IN THE DRAWING:

A marked-up copy of Figs. 5A and 5B is enclosed along with a replacement sheet. Approval is requested.

FIG. 5A

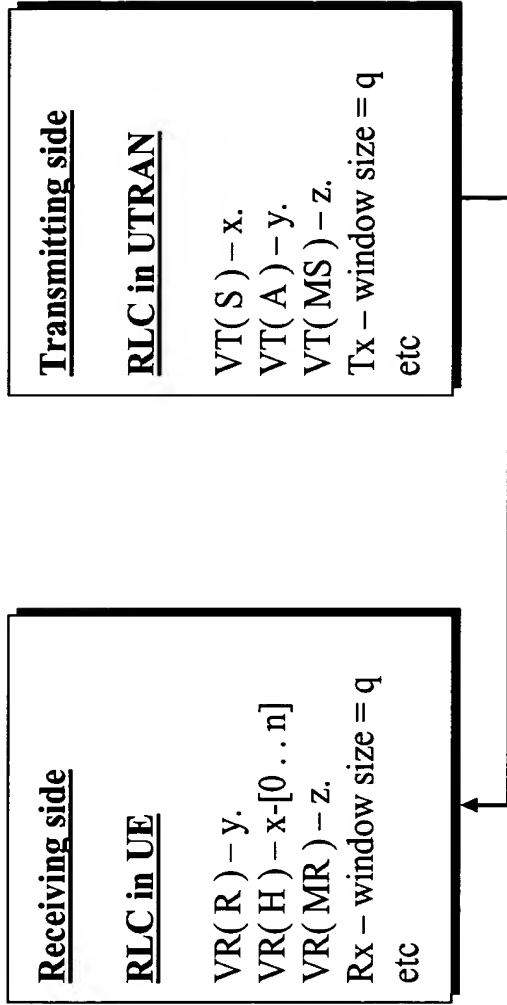
In Fig. 5A, please replace "VR(A)-y." with --VT(A)-y.-- on the transmitting side; and

In Fig. 5B, replace "VR(A)-0." With --VT(A)-0.-- in the transmitting side.
